Sequoyah Nuclear Plant Units 1 & 2  
Facility Operating License Nos. DPR-77 and DPR-79  
NRC Docket Nos. 50-327 & 50-328

Subject: **SEQUOYAH NUCLEAR PLANT (SQN), UNITS 1 AND 2 – PROPOSED TECHNICAL SPECIFICATION (TS) CHANGE, "ULTIMATE HEAT SINK (UHS) TEMPERATURE LIMITATIONS SUPPORTING ALTERNATE ESSENTIAL RAW COOLING WATER (ERCW) LOOP ALIGNMENTS (TS-SQN-13-01 AND 13-02)"**

**ENCLOSURE**  
**TS-SQN-13-01 and 13-02**

Evaluation of Proposed Change

**FIGURE 1 – SIMPLIFIED ERCW FLOW DIAGRAM**

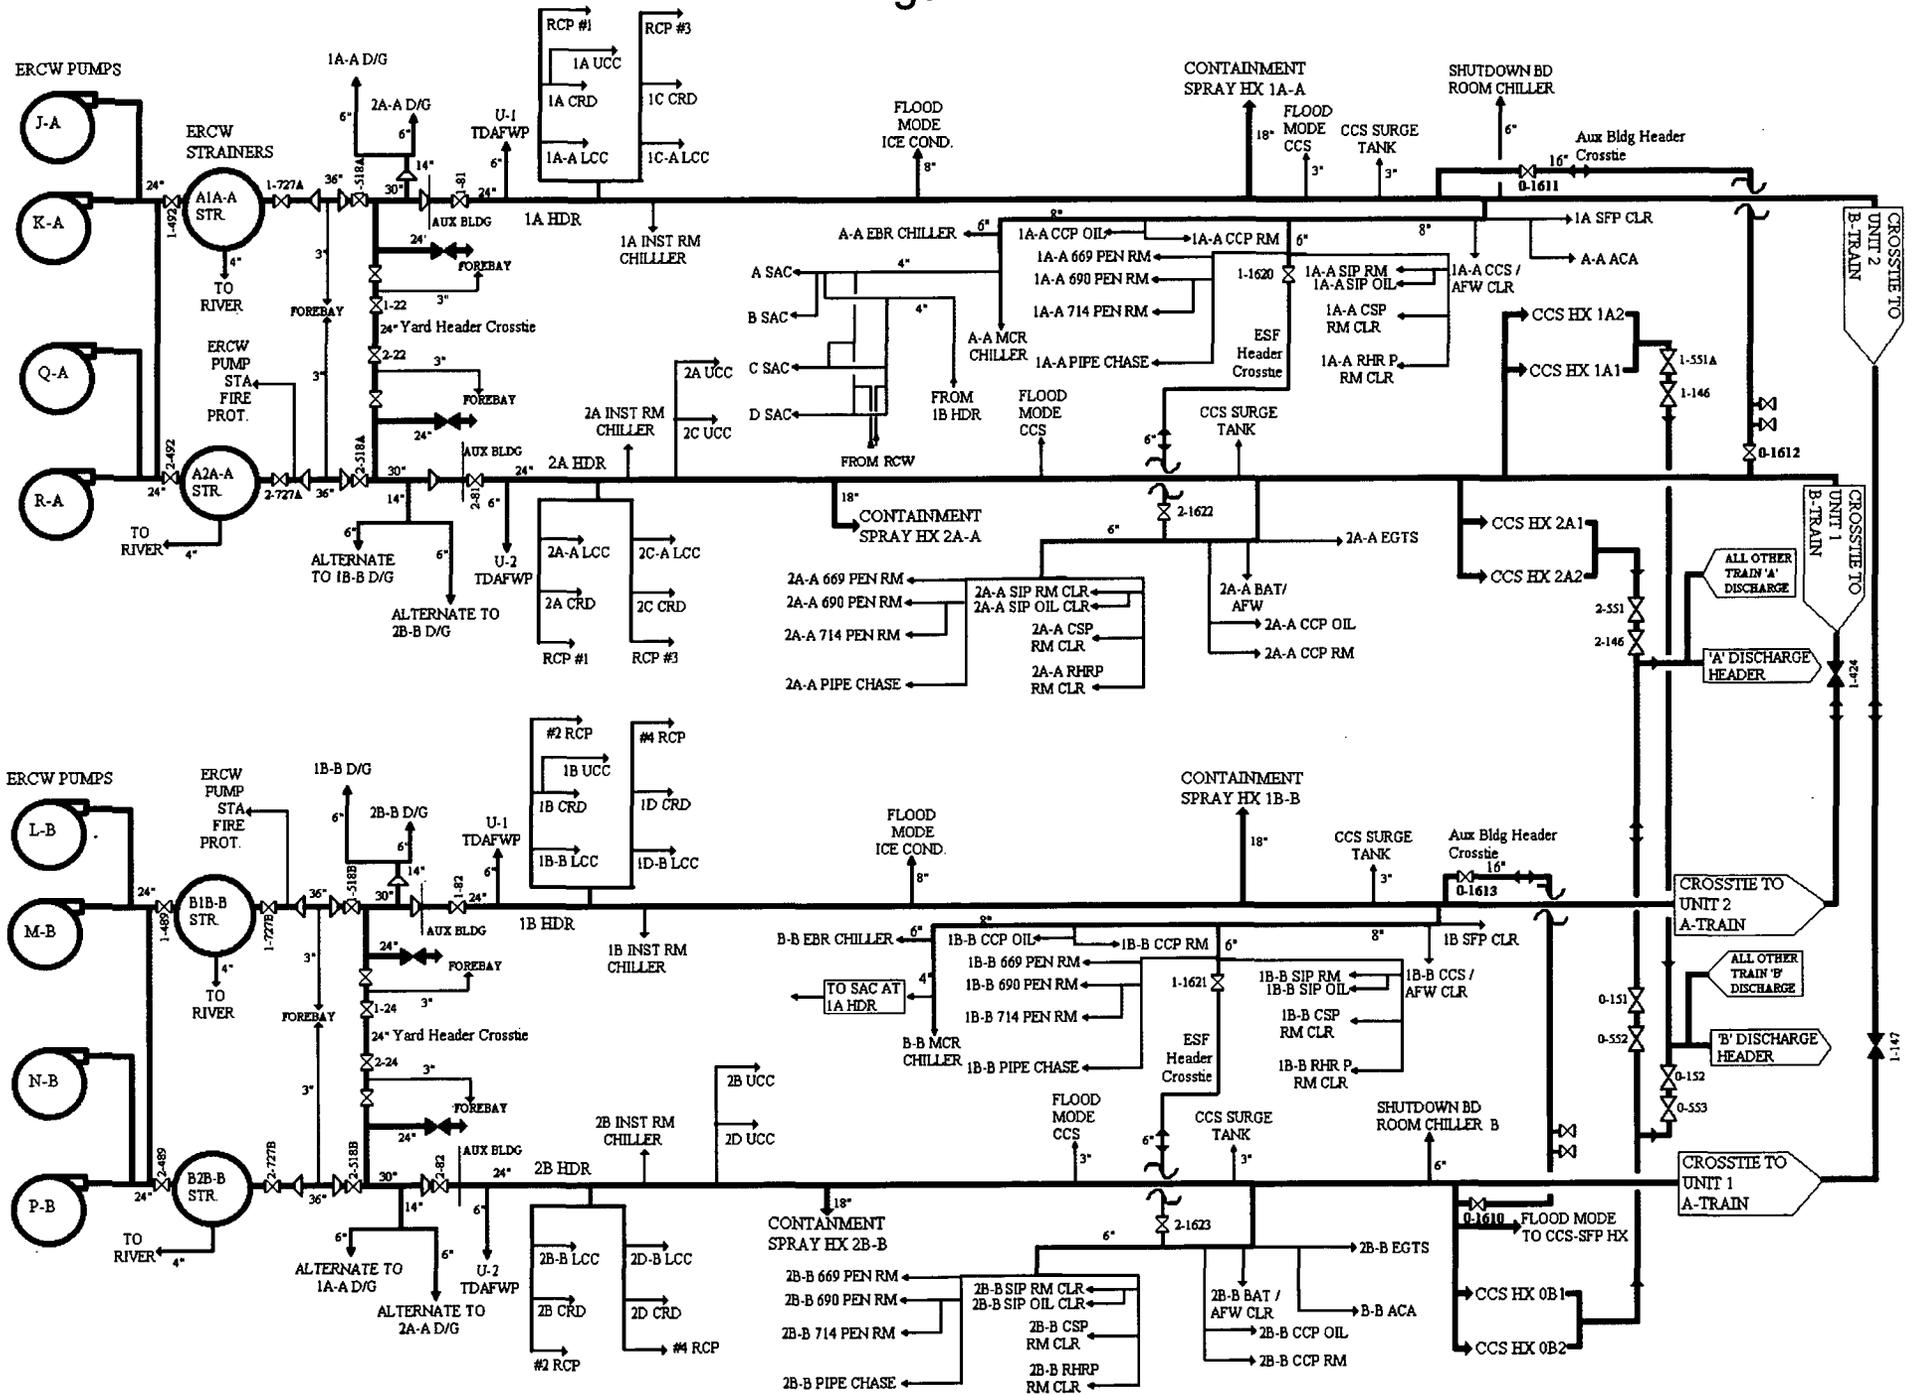
The ERCW system draws water directly from the Tennessee River (Chickamauga Lake). The ERCW pumping station is located within the plant intake skimmer structure, and has direct communication with the main river channel for all reservoir levels including loss of the Chickamauga Dam. The ERCW headers are crosstied downstream of the ERCW pumps and can be crosstied downstream of the ERCW supply strainers, referred to as yard header crossties (refer to Figure 1).

The ERCW system piping is arranged in four headers (1A, 1B, 2A, and 2B), each serving certain components in each unit as described below (refer to Figure 1):
